ADDENDUM 1

REF: Bid 2022-09 Portable Classroom Improvements at Five Schools

The following changes are made a part of the Drawings and Specifications for the project named above. Receipt of this Addendum is to be acknowledged in the space provided on the Bid Form. Failure to do so may subject the Bid to be considered as non-responsive.

² SMIITHSBURG RISER DIAGRAM E304 NOT TO SCALE

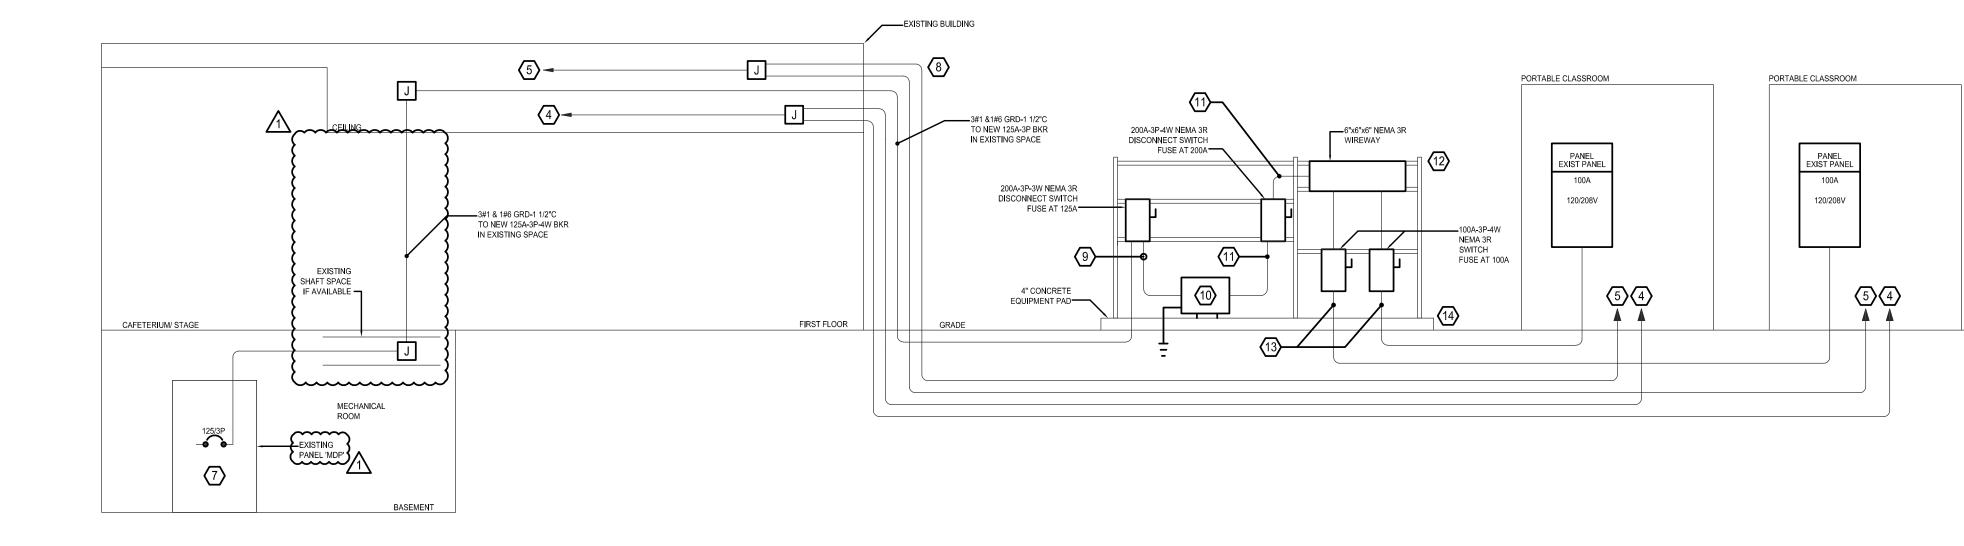
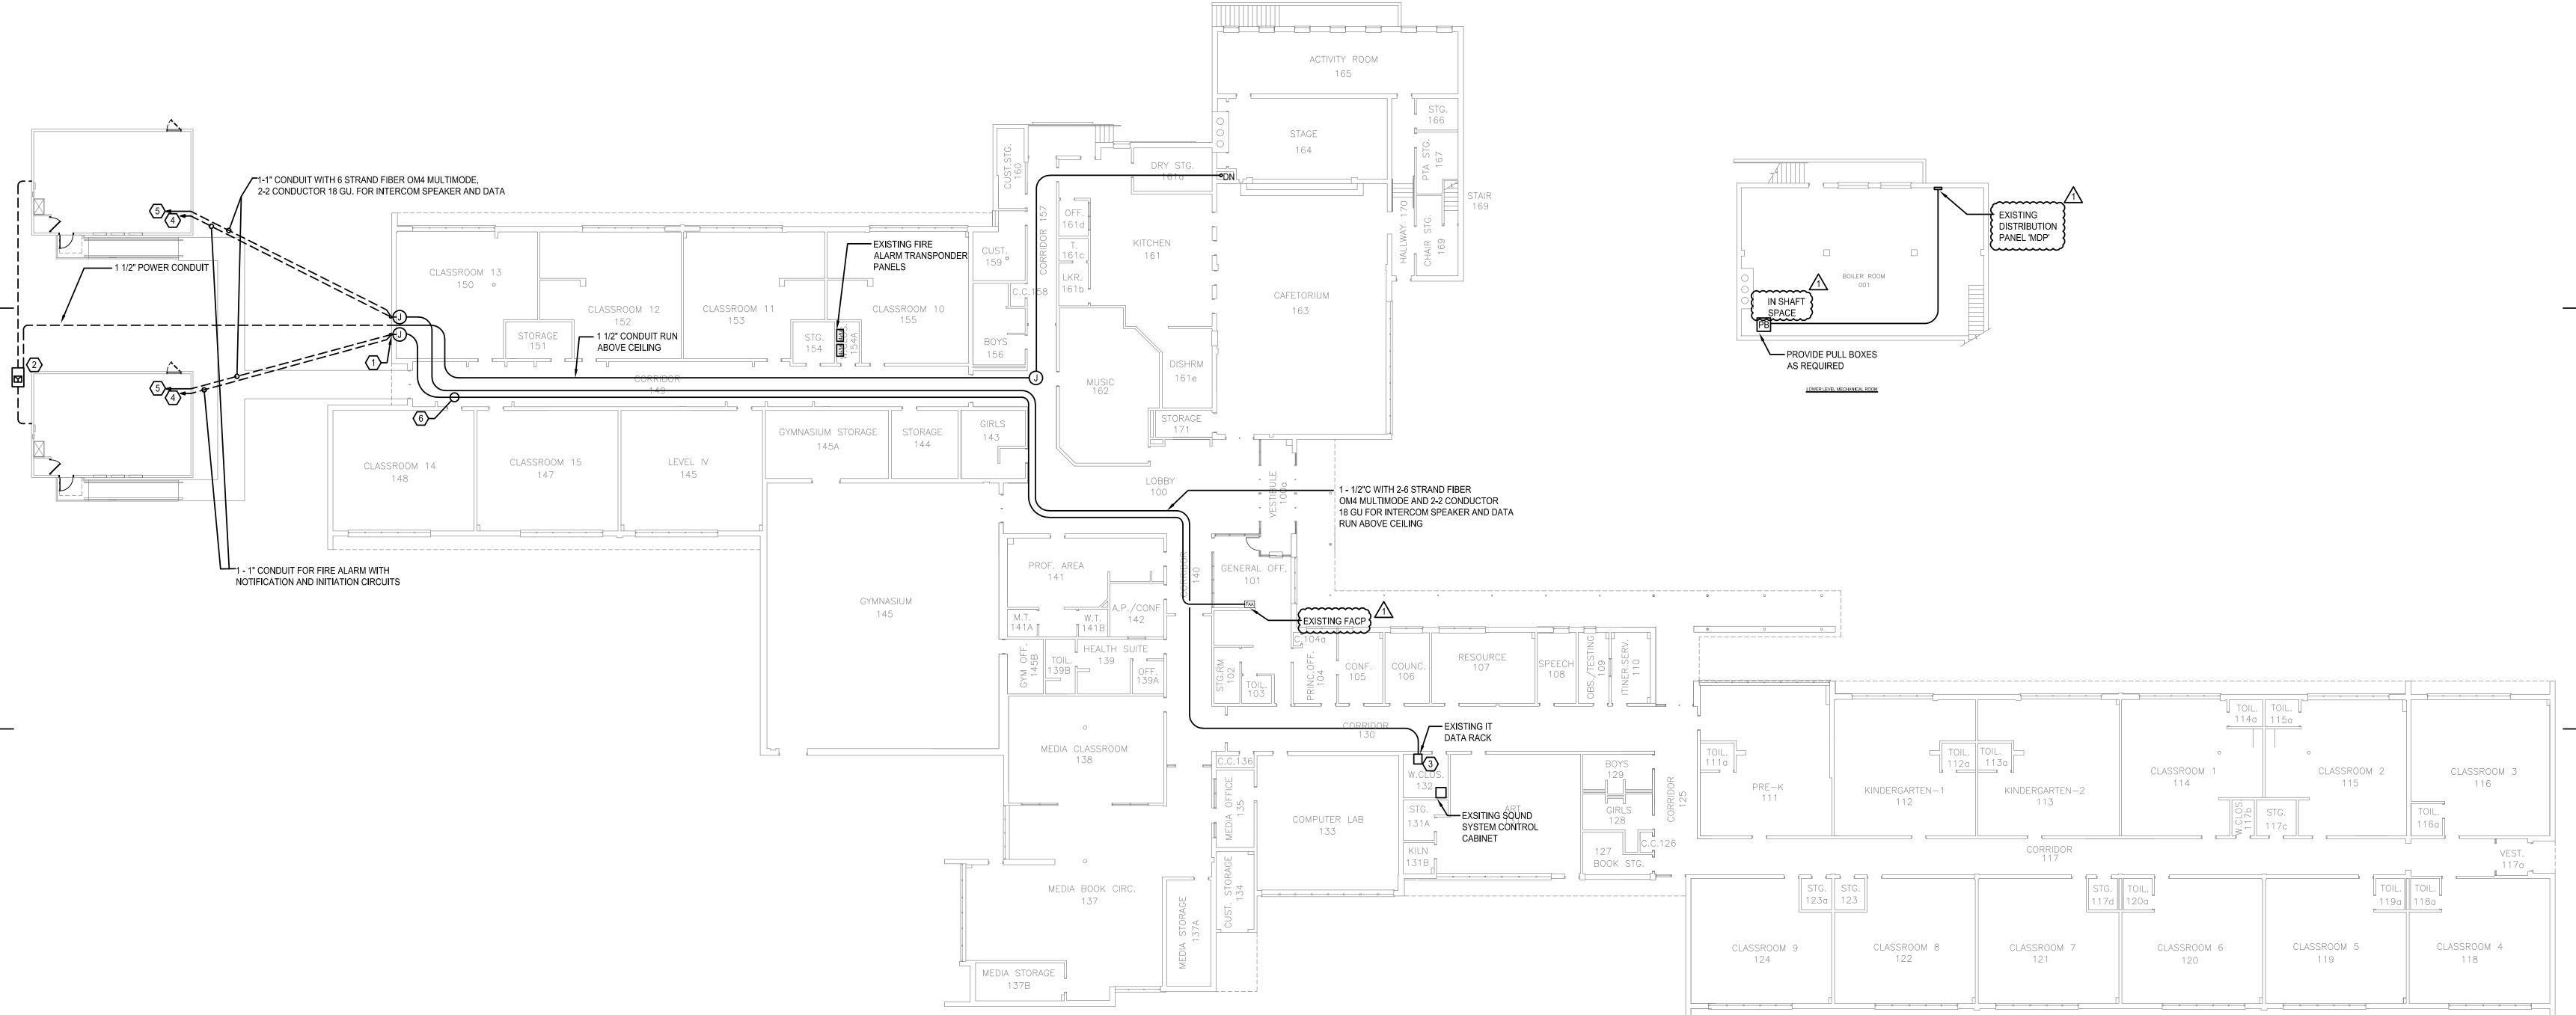
- 1.17 Q: Drawing E304 refers to Smithsburg High School.
 A: There is no work at Smithsburg High School. Sheet E304 references work at Smithsburg Elementary School.

Smithsburg ES - The Fire Alarm Annunciator Panel (FAAP) where noted on Drawing E304 in General Office 101 is actually the Fire Alarm Control Panel (FACP), and the (2) Transponder Panels shown in IT Room 154A do not exist. The required routing for the new 480V feeder from existing Panel MDP (not 'HDP', this designation is in error) is in no way accurately shown on Drawing E304, this is drawn to denote a vertical shaft. The shaft extends horizontally a significant distance with several turns and the drawing should be corrected to reasonably indicate what is required.

A: See Addendum Item 1.23. Revised MEP Drawings are attached to this addendum.

1 WILLIAMSPORT HIGH SCHOOL E305 1/32" = 1'-0"

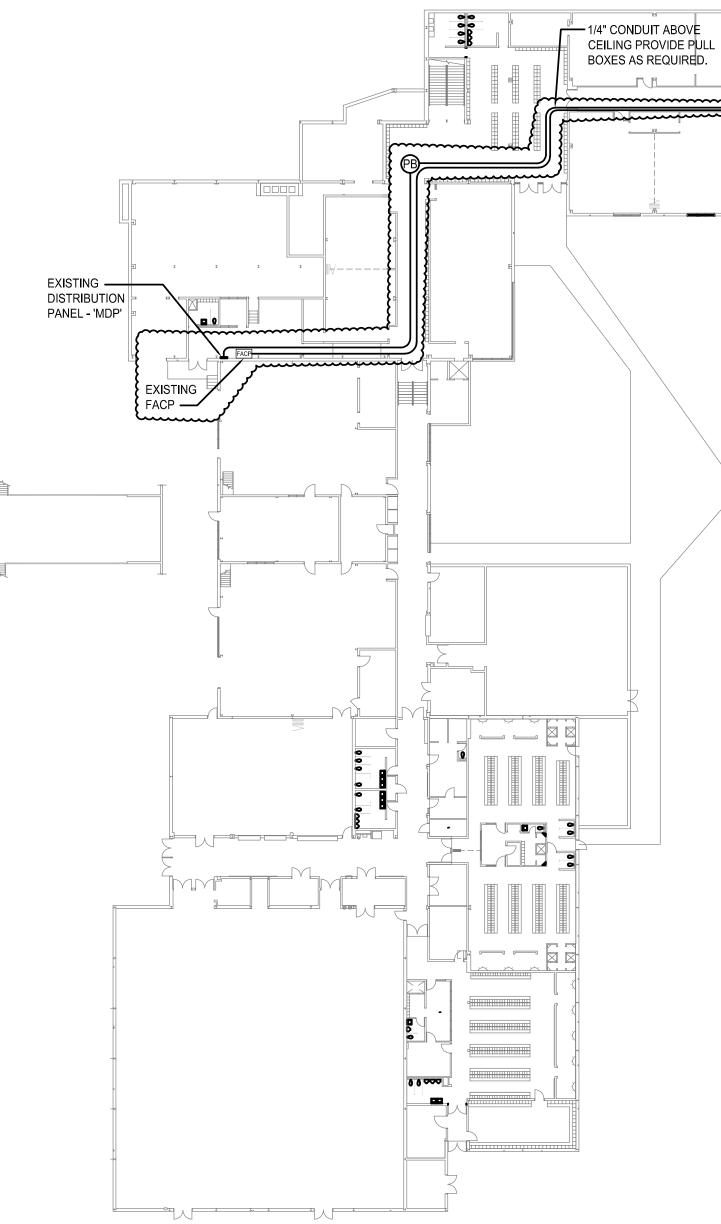
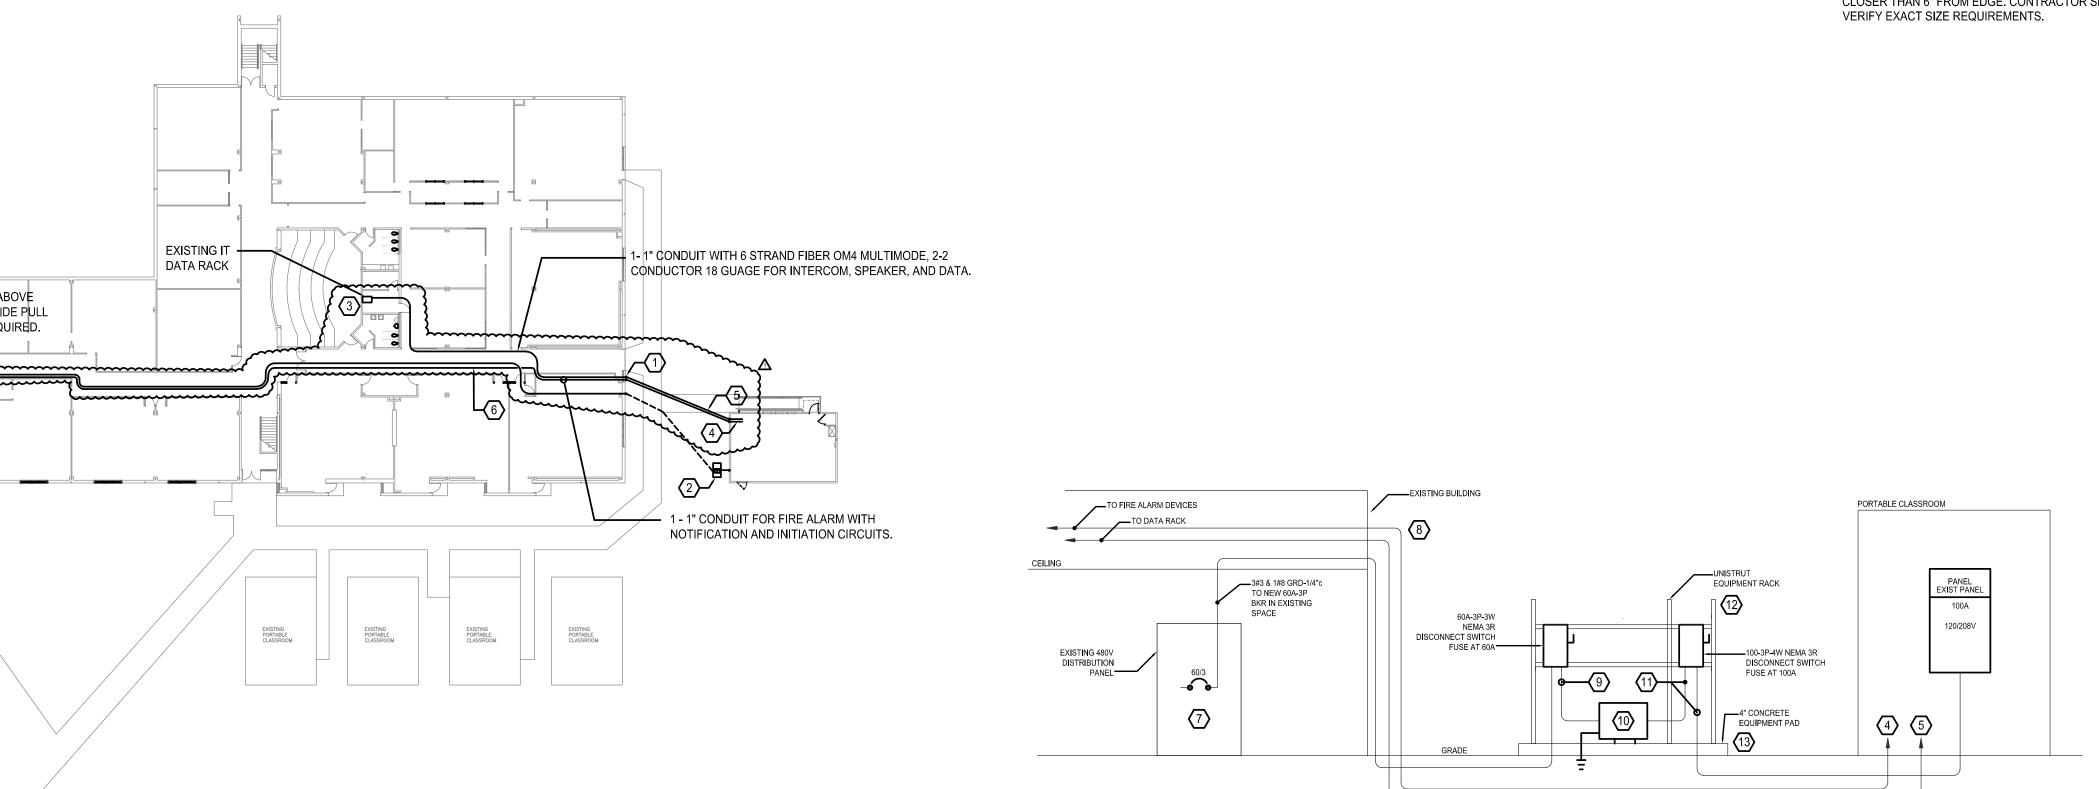
1.22 Q: **Williamsport HS** - Consideration for source of power for the 5th/added Portable should be given to the existing Transformer/Secondary Panel currently feeding the existing (4) Portables. There is actually no Fire Alarm Control Panel (FACP) where noted on Drawing E305 in the same room with the IT Data Rack. It is elsewhere and time did not permit further investigation in this regard.

- 1.27 **DELETE** E302 and **REPLACE** with revised E302 attached to this addendum. Note that the incorrect portable classroom location is shown on this drawing. Bidders shall assume that new portables are 200 feet away from the plan northwest corner of NHHS, and shall route all utilities to the new location as shown on the sheets referenced in Addendum item 1.24.
- 1.28 **DELETE** E303 and **REPLACE** with revised E303 attached to this addendum.
- 1.29 **DELETE** E304 and **REPLACE** with revised E304 attached to this addendum.
- 1.30 **DELETE** E305 and **REPLACE** with revised E305 attached to this addendum.
